Schedule 5 Notice for Permit Variation Application – EPR/XP3832NV/V004

A permit variation application was submitted by Ramboll, on behalf of Angus Fire Limited (referred to hereafter as "Angus Fire" or "the Client") to the Environment Agency (EA) on 29 April 2025. The permit variation application was to vary the Environmental Permit EPR/XP3832NV/V004 for the Angus Fire site located at Station Road, Bentham, Nr Lancaster, LA2 7NA (the "Site").

The application proposed to update the existing permit to include a waste operation to allow for treatment of contained stormwater collected on the Site and post-treatment discharge through a new discharge point (W2). The new discharge point is located at the sampling point for the discharge.

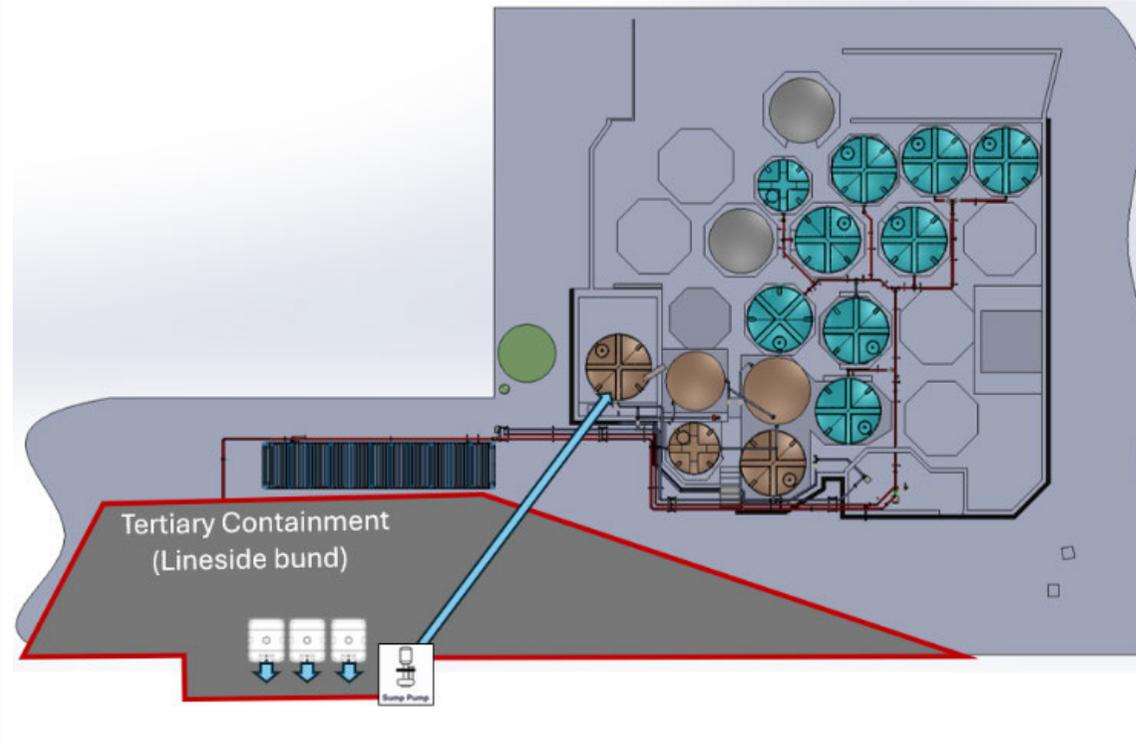
<p>8. Containment</p>	<p>With regard to transfer of potentially contaminated stormwater water from</p>	<p>Various options have been considered. The proposed approach has been selected as it fulfils three key criteria:</p> <ol style="list-style-type: none"> 1. The management and decanting of IBCs is carried out within the boundary of a containment protection area to reduce the risk associated with the loss of containment during storage and handling

IBCs to the treatment plant confirm:

(a) How this material is transferred without risks of loss of containment.

(b) The inspection/maintenance systems on these transfer routes.

2. Minimise the movement and handling of IBCs both from an employee and forklift truck movement perspective
3. Enables the IBCs to be emptied in a timely way that minimises the risks associated with: the loss of containment during the transfer; impacts on the throughput of the Treatment Train operation; and consistency of the nature and characteristic of the influent standard.

The proposed method for the transfer of potentially contaminated stormwater present in IBCs is to move the IBCs to the catchment pit of the tertiary containment area (Lineside bund), open the IBC tap and allow the stormwater within to feed into the holding sump. From this area, the pumping system that is already in place will transfer the potentially contaminated stormwater from the Lineside Bund into the pre-treatment storage tanks. For clarity, a conceptual model of the process is outlined in the figure below:

<p>In addition to meeting the three key on-site criteria described above, the proposed transfer method addresses the queries presented within the EA's comment, as further outlined below:</p> <ul style="list-style-type: none"> (a) The transfer of the contained stormwater occurs within the bunded area of the Site that is isolated from external receptors. There is no transfer of potentially contaminated stormwater over areas of the Site that are not bunded/located within tertiary containment area. <p>NB: As the stockpile of contained stormwater is reduced, IBCs held in areas of the Site with less effective containment will be moved into areas of effective containment at the earliest opportunity.</p> <ul style="list-style-type: none"> (b) The proposed inspection and maintenance of the transfer areas are described in the response provided to Question 20. As the transfer is undertaken within existing containment areas that are subject to inspection and maintenance no additional inspections are considered necessary.

For clarity, a conceptual model of the influent treatment system is provided in the Figure below.

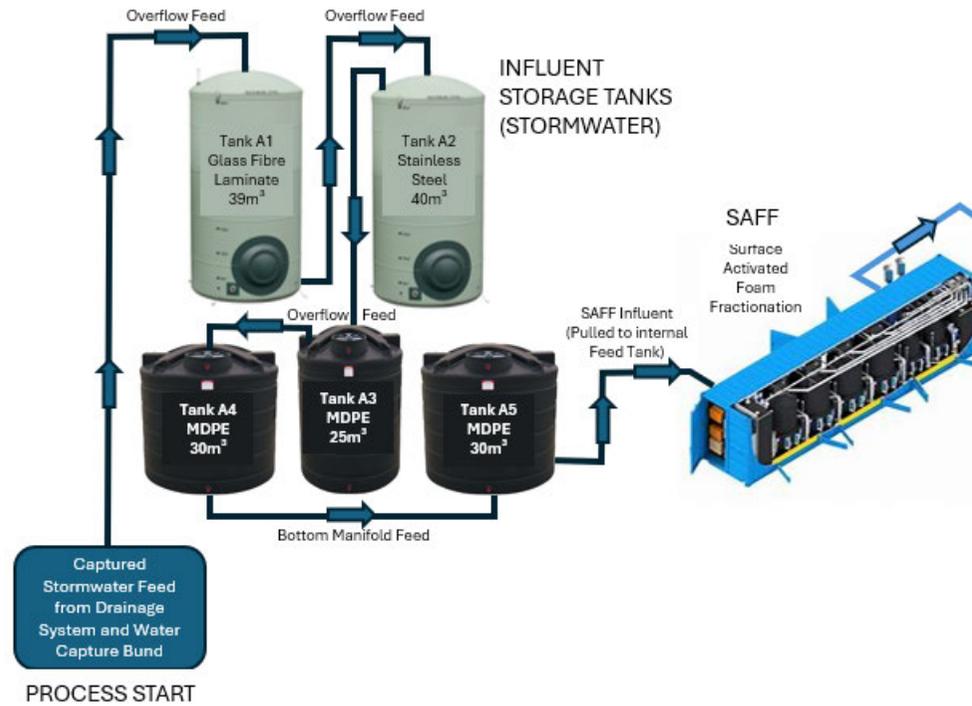
<p>10. Containment</p>	<p>For each pre-treatment and post-treatment storage tank within the containment bund, define the control systems to prevent overflow (such as high-level alarms and high-</p>	<p>Pre-treatment Storage Tanks</p> <p>The contained stormwater is pumped from the collection bund into Tank A1, which once filled will overflow via a top feed line into Tank A2. In turn Tank A2 will overflow via a top feed line into Tank A3. Tank A3 overflows via a top feed line into Tank A4, however, Tanks A4 and A5 are connected by a bottom fed manifold so they effectively fill simultaneously which ensures the influent fed to the SAFF plant has a minimum blended volume of 55m³ to 60m³.</p>

high level shut off valves) and confirm the tank volumes at which these occur.

High and high-high level alarms are not installed on the pre-treatment tanks. However, the fact that they are top filled (with the exception of A4 and A5 which are connected) prevents an incident that results in loss of containment from one tank being exacerbated by the feed from other tanks.

In addition, the bunds are monitored by CCTV.

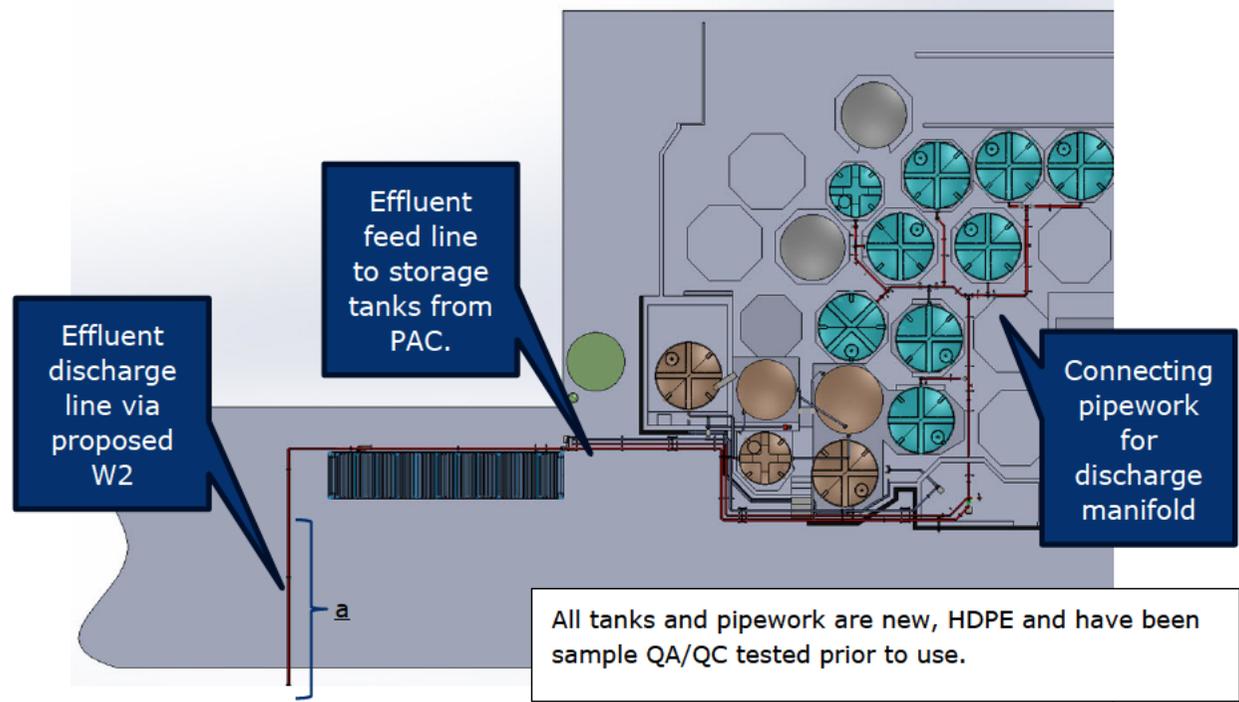
<p>14. Discharge of Treated Water.</p>	<p>Demonstrate how AFL will ensure that water flow in the River Wenning remains sufficient to allow discharge of treated stormwaters in an on-going drought situation.</p>	<p>A H1 Sensitivity Assessment was undertaken to determine the impact of treated waters discharged to the River Wenning at extreme low flow scenarios.</p> <p>The Sensitivity Assessment was completed using the maximum compound concentrations shown in Table 10-1 of the Permit Variation Application Report and Q97.5, Q99.5, Min Flow (recorded on 22 May 2025) and Q99.95 flows of the River Wenning. The flow rates were determined using flow data provided from monitoring station 72009, Wenning at Wennington¹.</p> <p>The H1 Sensitivity Assessment concluded that the process contributions for all compounds are below 4% of Environmental Quality Standard (EQS) for all flow scenarios of the River Wenning in Test 2.</p>

Substances that have a process contribution of <4% are below the EQS insignificance threshold. That is, the impact of the discharge of these compounds to environmental receptors is insignificant even at extreme worst case flow scenarios.

Based on the Sensitivity Assessment completed, the monitoring parameters described in the Permit Variation Application Report are considered appropriate for extreme low flow scenarios.

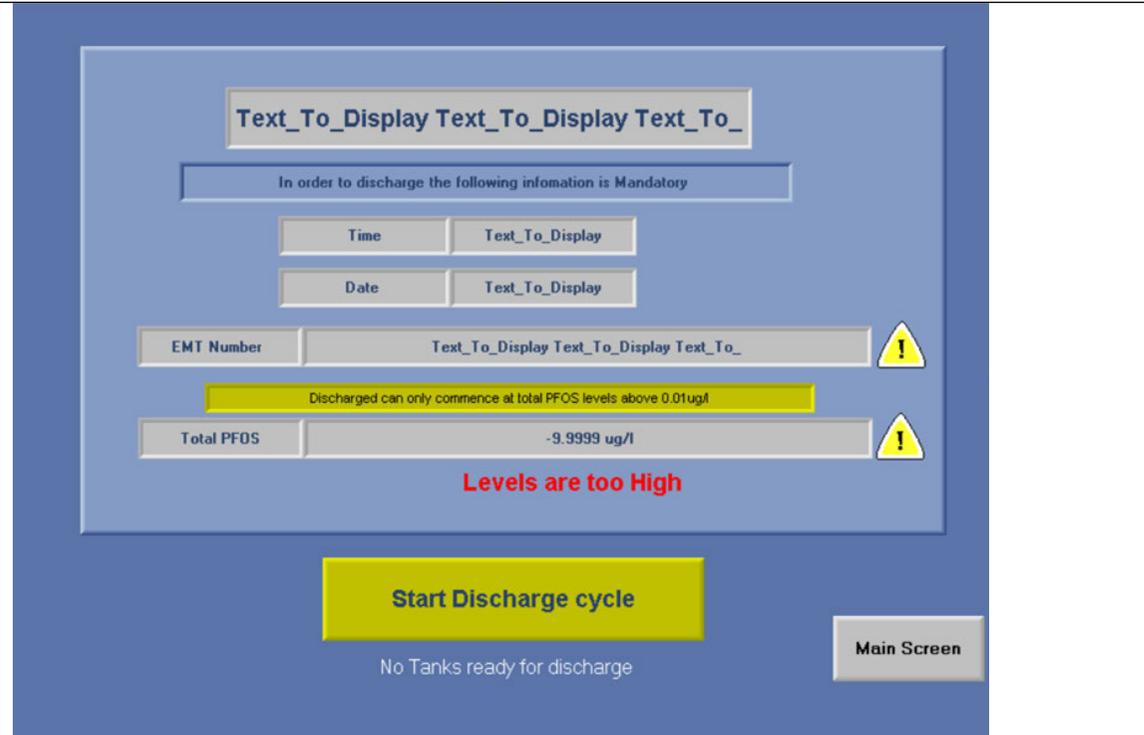
<p>16. Discharge of Treated Water.</p>	<p>Demonstrate the PLC system that is used to ensure that treated stormwater can only be discharged by certain site operatives and only after input of laboratory analyses results and laboratory codes (including how unauthorised persons cannot access the PLC system to discharge and how repeat</p>	<p>The PLC discharge system has a user access password. These passwords are set by the administrator. The administrator account is also separately password protected.</p> <p>Users must first log in by touching their name and entering their individual passwords. (Text_to_Display boxes are where user information is displayed).</p>

laboratory codes cannot be input again to trigger release of treated stormwater).

Upon successful entry of credentials, the following screen is displayed.

Until all fields have been populated the "start discharge cycle" button is disabled therefore cannot be pressed/activated.

Date and time are populated by the PLC. The EMT number (unique reference number from the lab report) must be entered and the total PFOS entry must be entered under the set limits. The PLC will not accept a value equal to or greater than 0.01ug/l to be entered.
